EMERGENCY AIRWORTHINESS DIRECTIVE

Number: **G-2021-0014**

ATA 28 – Fuel –Cylinder Quick Shut-off Valve Mounting Flange – Inspection / Replacement

Figure 1: *CB437 Flanged Adaptors for Quick Shut-Off (QSO) valves*

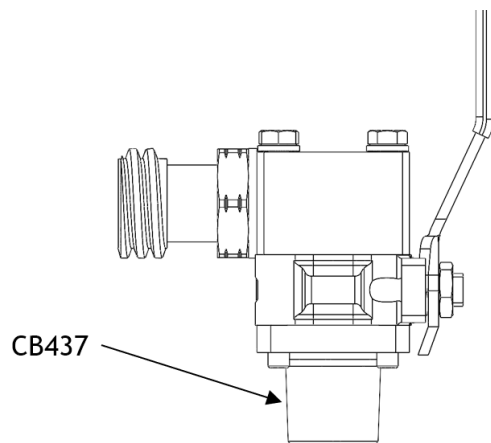
Certain Cameron Hot Air Balloon fuel cylinders are supplied with liquid offtakes that consist of a quarter turn ball valve mounted on a flanged adaptor (P/N CB437, see figure 1). Two recent batches of these adaptors have been manufactured with non-conforming (undersize) threads.

In certain cases, when the minimum sized adaptors are combined with cylinder bosses at maximum tolerance dimension and assembled to fuel cylinders, the thread can impinge (“bottom out”) on the cylinder boss. Although the required tightening torque value can be achieved at installation, the torque required to unscrew the flange could be below the minimum value. In extreme cases the adaptor may be unscrewed by hand.

4. From the 04 October 2021 (the effective date of AD 2021-0010-E), do not install an affected part on any cylinder.
5. Within 4 months after 04 October 2021 (the effective date of AD 2021-0010-E), modify each cylinder by replacing the P/N CB437 issue F QSO flanged Adaptor, with a P/N CB437 issue G (or later issue) QSO flanged adaptor in accordance with the instructions of the SB, or by replacing the QSO valve assembly with a handwheel valve part No CB0824-0001 (this part has a Rego-type hose connection).
